Re: Draft Environmental Assessment for the Proposed Spring Valley Wind Project

The Center has serious concerns regarding this project. We offer the following comments upon our review of the Environmental Assessment ("EA")

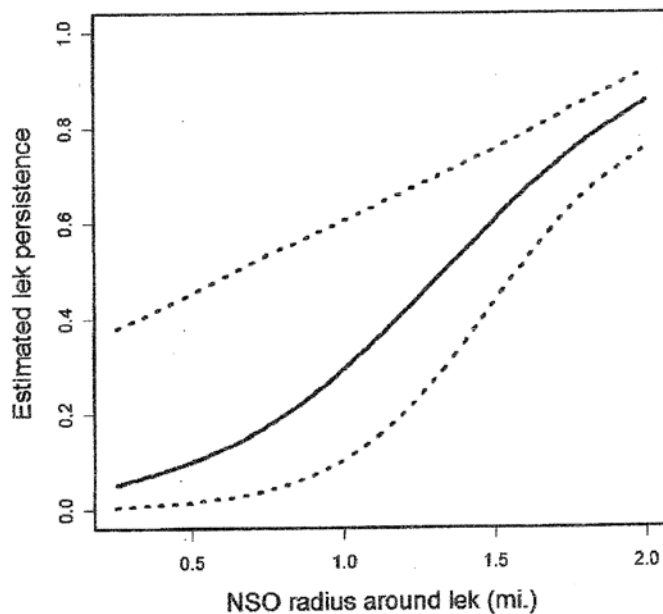
Walker et al. (2007) provides an impact analyses model based on a 7-year dataset where probability of lek persistence is strongly related to the extent of

sagebrush habitat and energy development within 4 miles of the lek and the extent of agricultural tillage in the surrounding landscape. The estimated probabilities of lek persistence are only reliable for the length of the dataset, and it is not understood how other stressors such as West Nile virus or invasive weeds will cumulatively impact sage-grouse over longer time periods. While increased no-surface occupancy (NSO) buffers alone are unlikely to conserve sage-grouse populations, results from Walker et al. 2007 suggest they will increase the likelihood of maintaining the distribution and abundance of grouse and should increase the likelihood of successful restoration following energy development. Figure 1 portrays the likelihood of lek persistence in relation to the distance of full scale energy development from the lek.

Based on recent research on oil/gas developments in Wyoming and Montana, the 3-mile buffer appears to be a reasonable set-back distance that will minimize the impacts on sage-grouse (Walker et al. 2007, Doherty et al. 2008). However, in light of the information provided, Colorado (Colorado Steering Committee 2008) and Wyoming (Governor's Executive Order 2008) adopted a 4-mile buffer to protect sage-grouse breeding habitat. Additionally, a BLM Instruction Memorandum from the State Director of Oregon and Washington limits the construction of wind energy grids (wind farms) to no closer than a 4.8 km (3 mile) radius of sage-grouse lek sites while other stipulations are also made for winter and brood rearing habitat as well as access roads and power lines (USDI – BLM, 2009).

We strongly encourage the Nevada State BLM Office and the Ely District to reconsider the 0.25 mile "no development" buffer for active sage grouse leks and recommend at least a 3-mile setback. The Ely District must also realize that this buffer may not adequately protect sage-
